**TITLE: AIR CONDITIONING- GENERAL- CONDITIONED SERVICE AIR SYSTEM
(CSAS) - INSTALL IMPROVED CSAS CONTROL UNIT (CCU-K05)**

MODIFICATION No.: 152075K15181

This page transmits Revision No.01 of Service Bulletin No.A320-21-1197

SERVICE BULLETIN No.: A320-21-1197

Figure A-GSAAA - Sheet 01

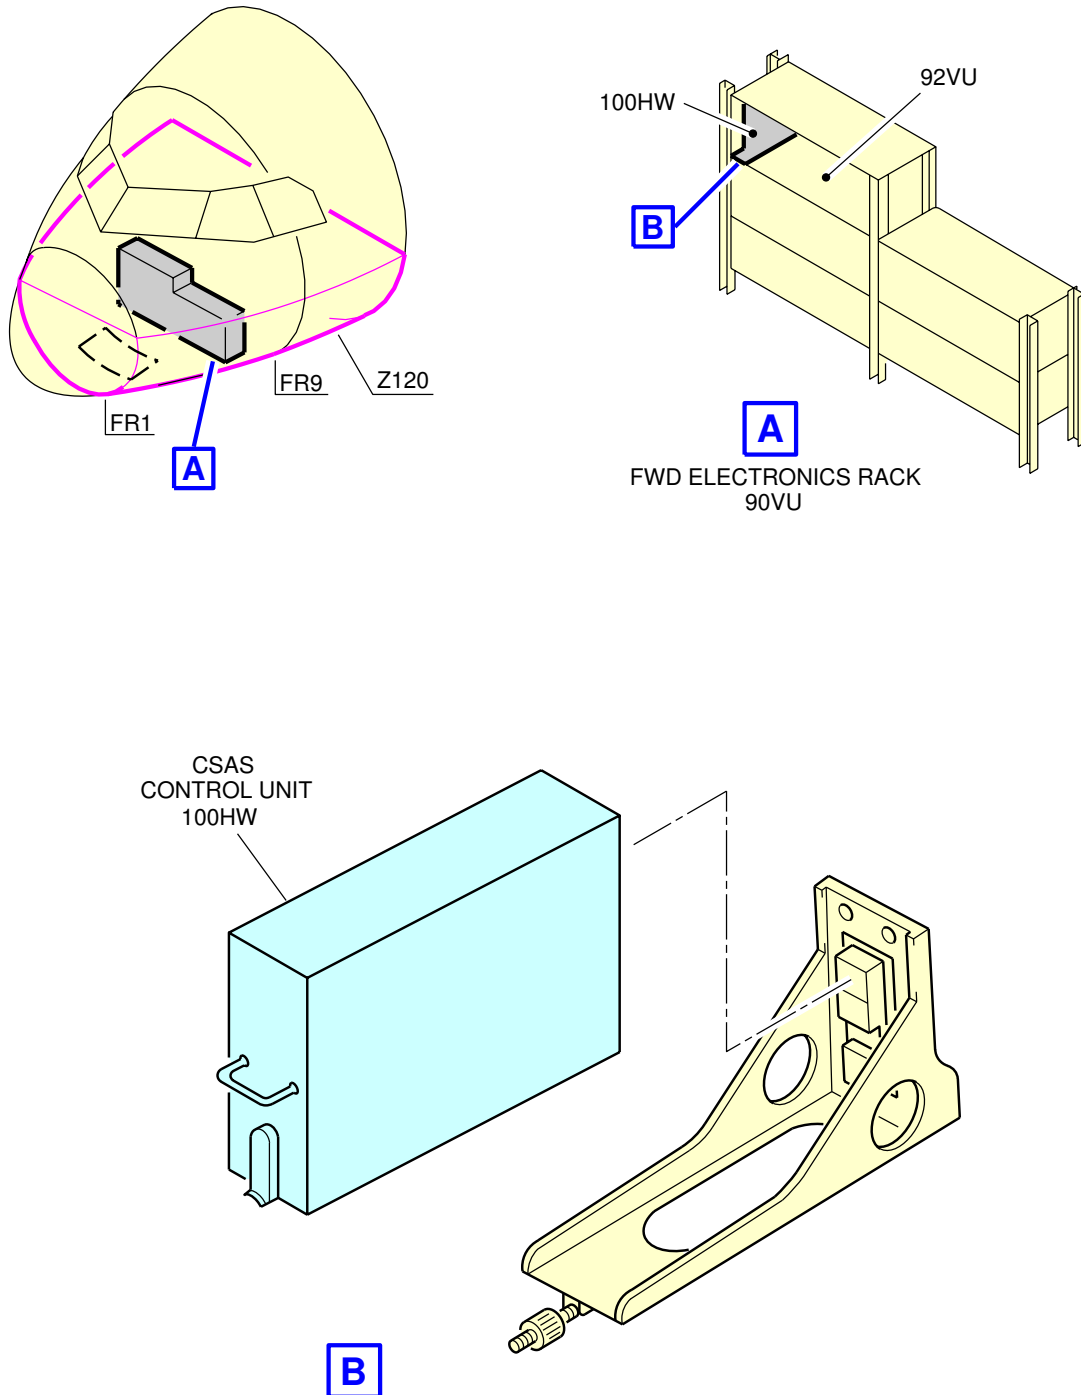
In-Service experience has identified necessary improvements in the system functionality of the Conditioned Service Air System (CSAS) Control Unit PN 3959A0000K04.

This Service Bulletin has been issued to inform operators of the issue of LIEBHERR AEROSPACE Service Bulletin No. 3959A-21-02, which updates the CSAS Control Unit software from PN 3959A1000S18 to PN 3959A1000S26.

Furthermore, it is necessary to re-identify the CSAS Control Unit from the PN 3959A0000K04 to PN 3959A0000K05.

Figure A-GBAAA - Sheet 01
Replace the CSAS Control Unit

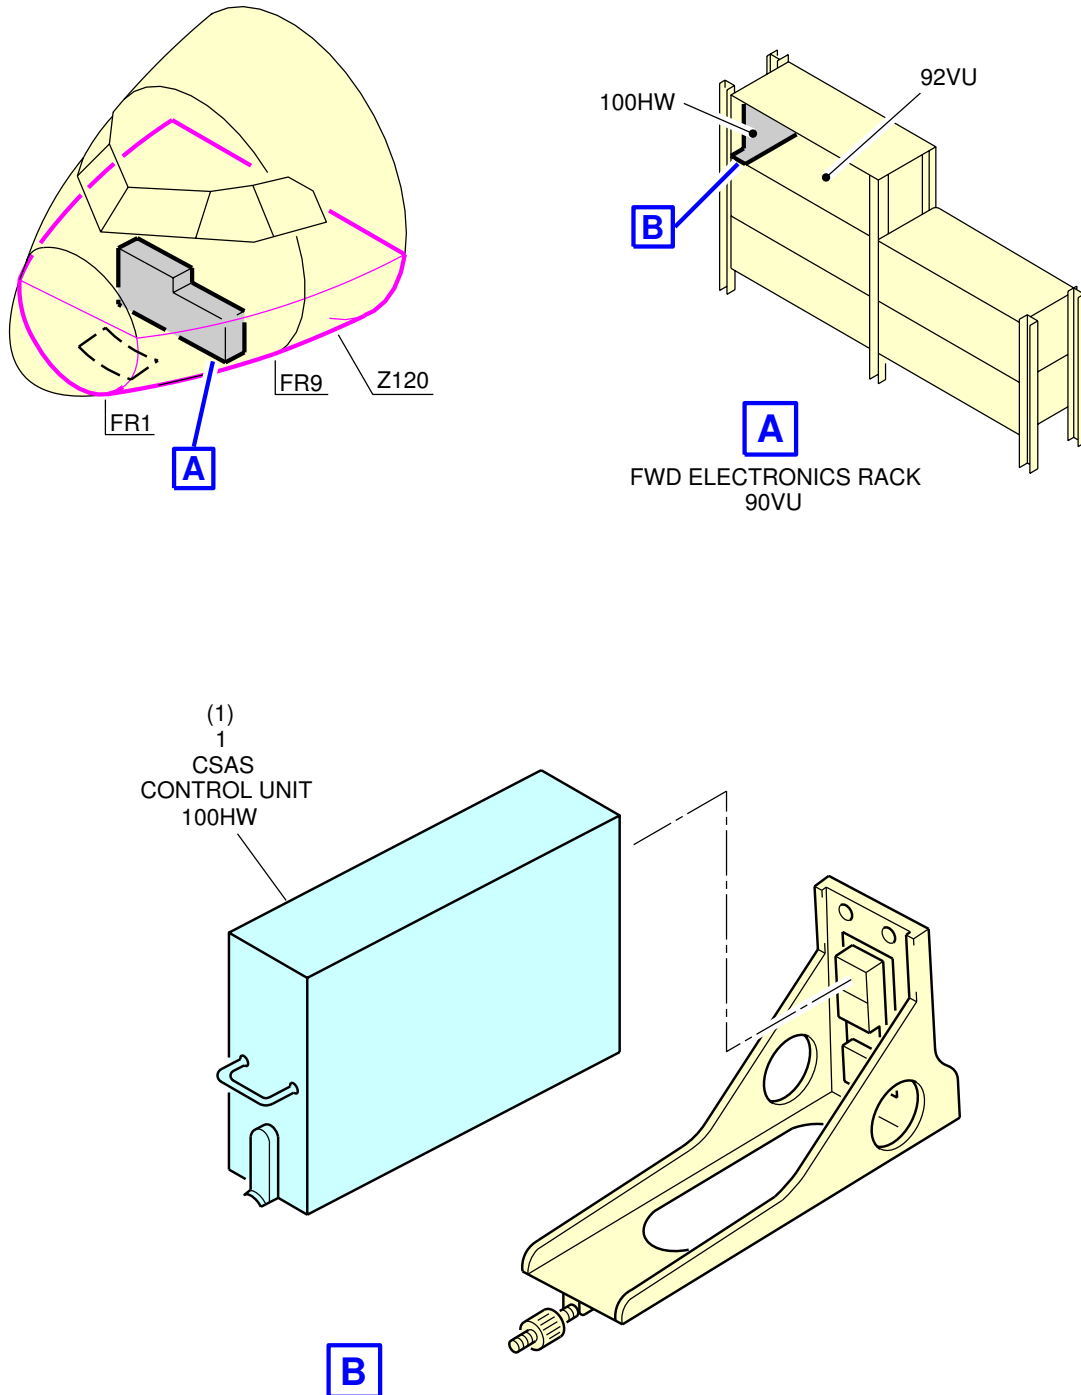
- (a) Remove, refer to AMM Task 21-58-34-000-001 and [Fig. A-GBAAA Sheet 01](#):

1 Controller-CSAS 3959A0000K04 Item (1)

- (a) Modify the CSAS Control Unit as given in LIEBHERR AEROSPACE Service Bulletin No. 3959A-21-02.

- (a) Install, refer to AMM Task 21-58-34-400-001 and [Fig. A-GBAAA Sheet 01](#):

1 Controller-CSAS 3959A0000K05 Item 1
